WESTWOOD HILLS 2ND ADDITION

Re: S/D 98-57 -- One-Step Final Plat of WESTWOOD HILLS 2ND ADDITION

Re: S/D 98-57 -- One-Step Final Plat of WESTWOOD HILLS 2ND ADDITION

STAFF REPORT
(One-Step Final Plat-Approved 5/21/98)

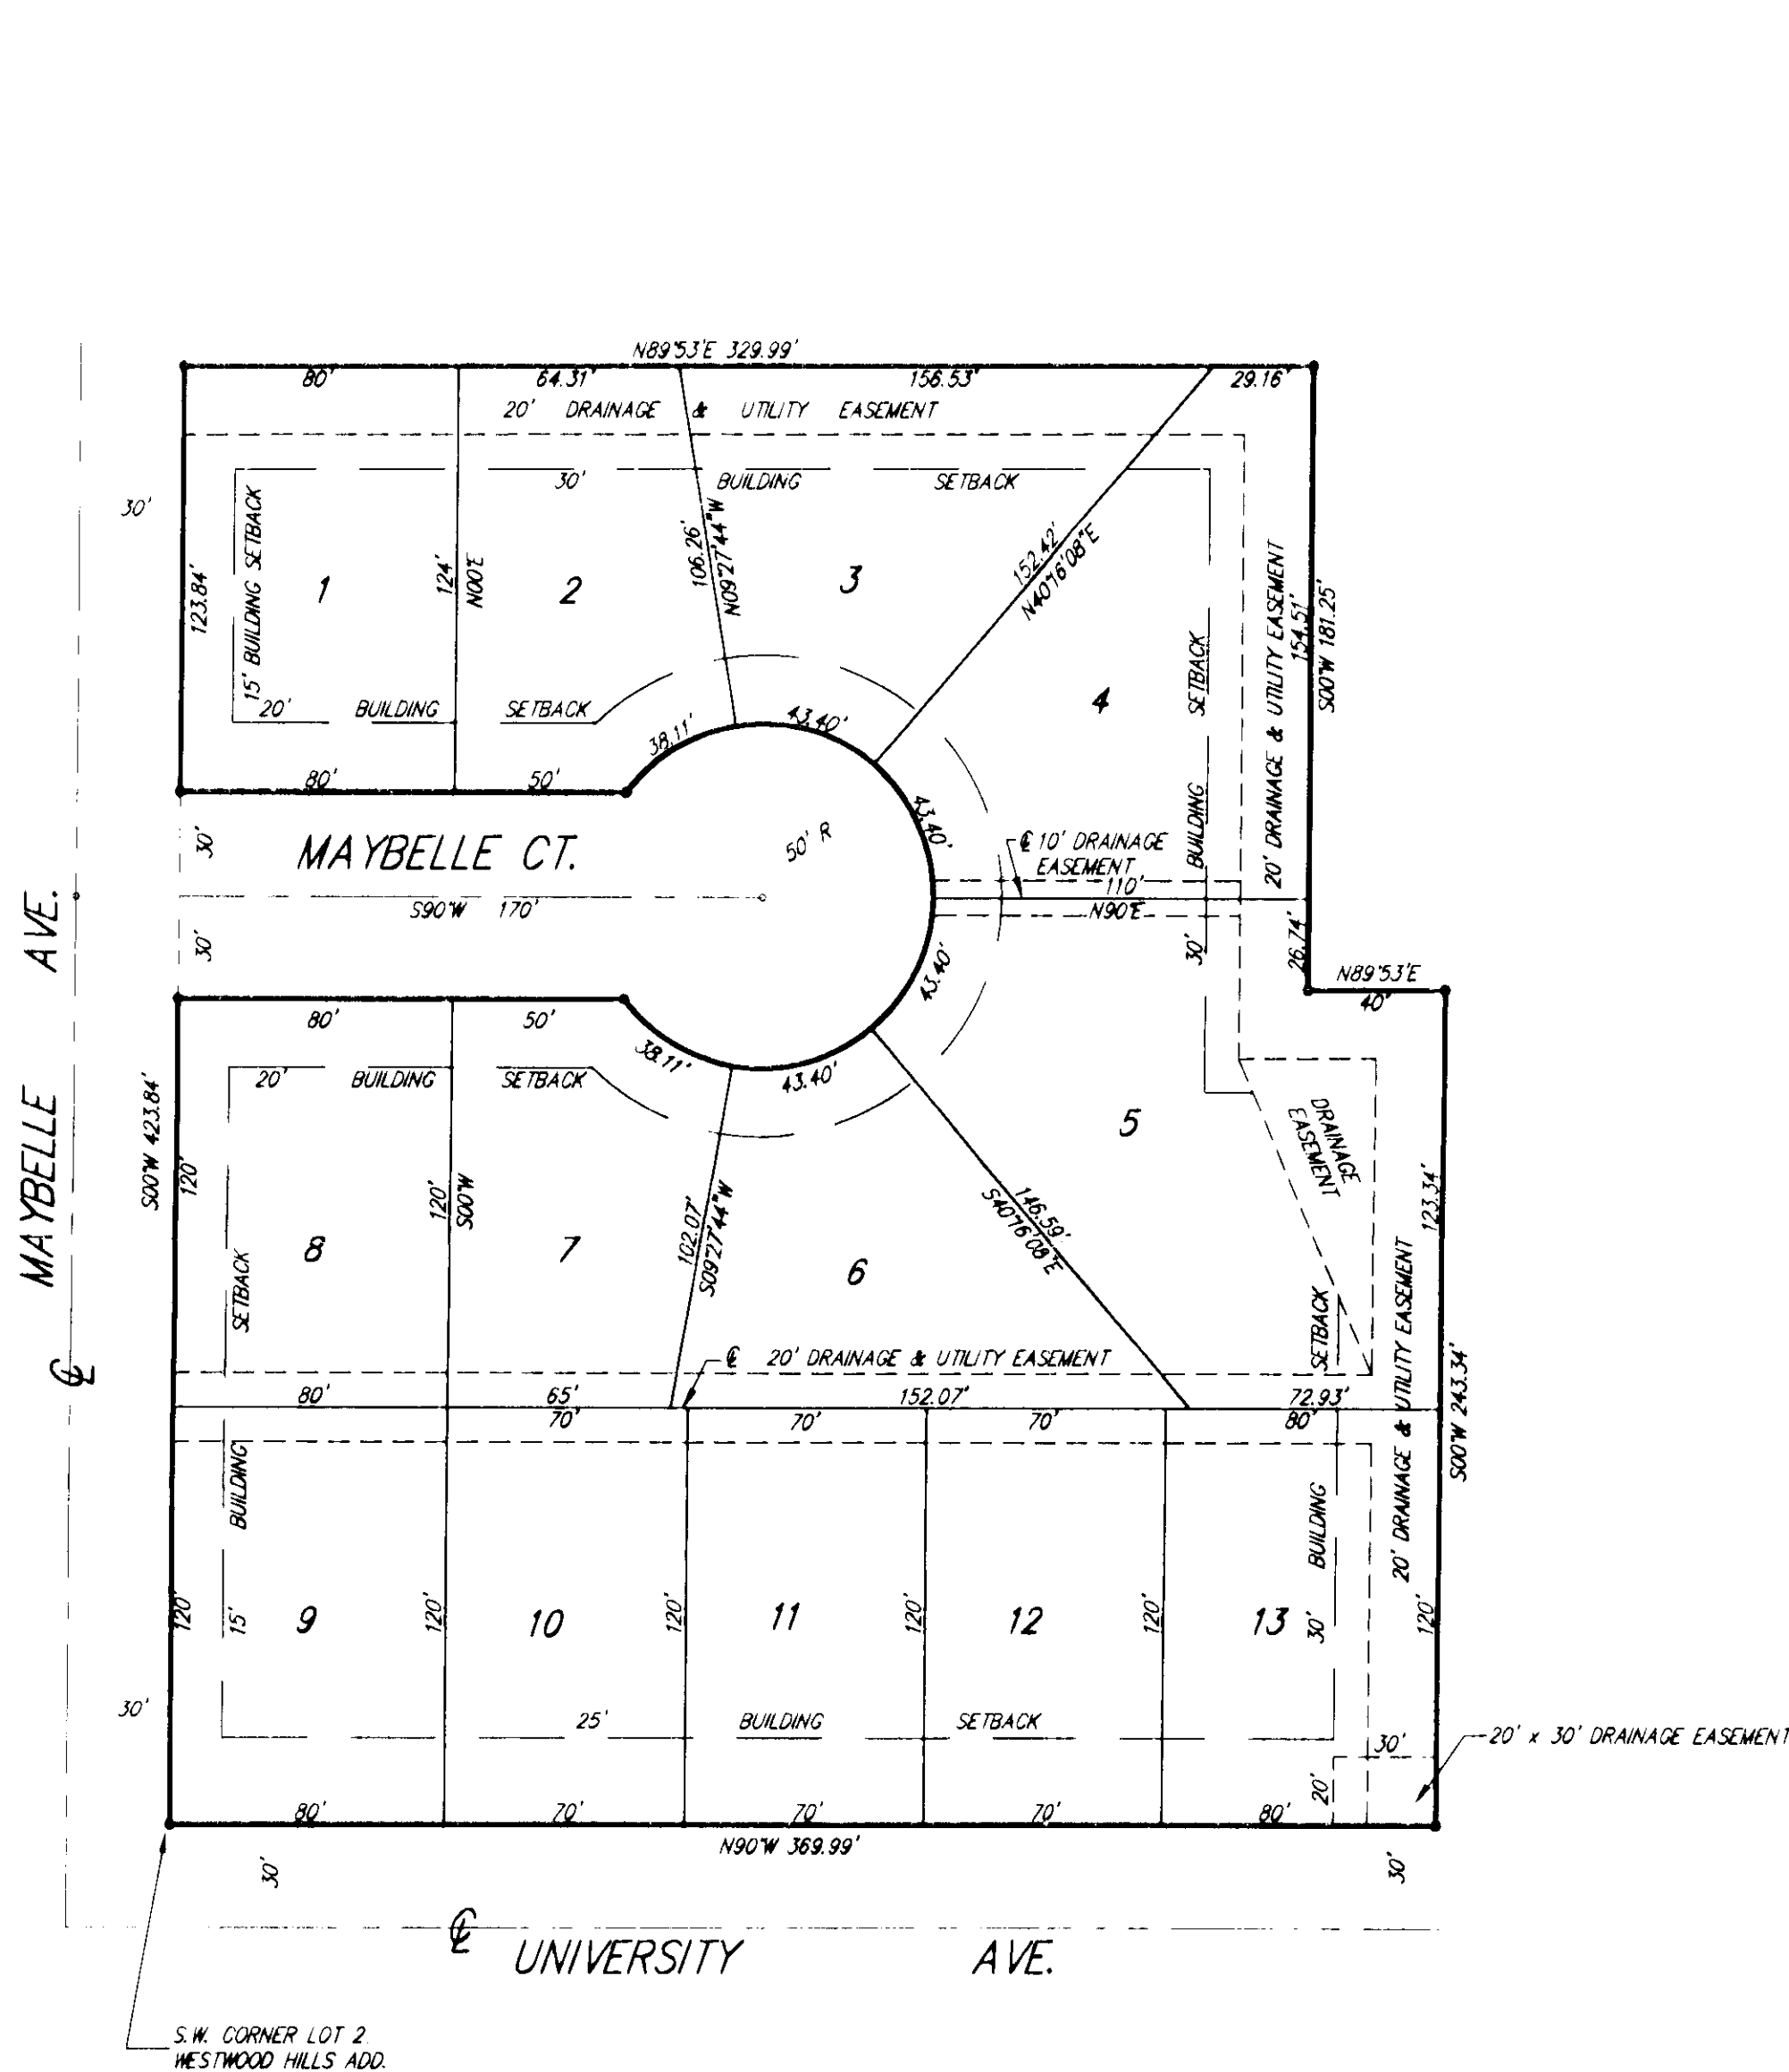
- A. City Engineering needs to indicate if any guarantees are required. Guarantees are required for the extension of water and sewer to serve the lots.

- C. City Engineering needs to comment on the status of the applicant's drainage plan. The drainage plan is approved. Drainage easement shall be denoted to cover the proposed storm sewer. A storm sewer guarantee will be required.

- D. The applicant shall guarantee the paving of the proposed interior street.
- E. The final plat tracing shall reference a tie point from a section corner and its distance to the plat.

- F. The perimeter of the plat does not coincide with the perimeter of Parcel 4 of the CUP and an administrative adjustment needs to be completed. In addition, the plat does not conform with the 50-foot setback imposed by the CUP along Maybelle and University Avenue (15-foot and 20-foot platted setback). MAPD recommends maintaining the standard 25-foot front yard setback along

University Avenue. An administrative adjustment needs to be completed for this setback revision.

- G. Traffic Engineering needs to comment on the need for any improvements to University Avenue and Maybelle Avenue. *No improvements are needed.*
- H. The applicant shall submit a covenant which provides for four (4) off-street parking spaces per all dwelling units in the plat. The covenant shall inventory the affected lots by lot and block number and shall state that the covenant runs with the land and is binding on future owners and assigns.

- N. Perimeter closure computations shall be submitted with the final plat tracing.
- O. Recording of the plat within thirty (30) days after approval by the City Council and/or County Commission.
- P. The representatives from the utility companies should be prepared to comment on the need for any additional utility easements to be platted on this property.
- Q. The applicant is reminded that a disk shall be submitted with the final plat tracing to the Planning Department detailing this plat. This will be used by the City and County GIS Department.
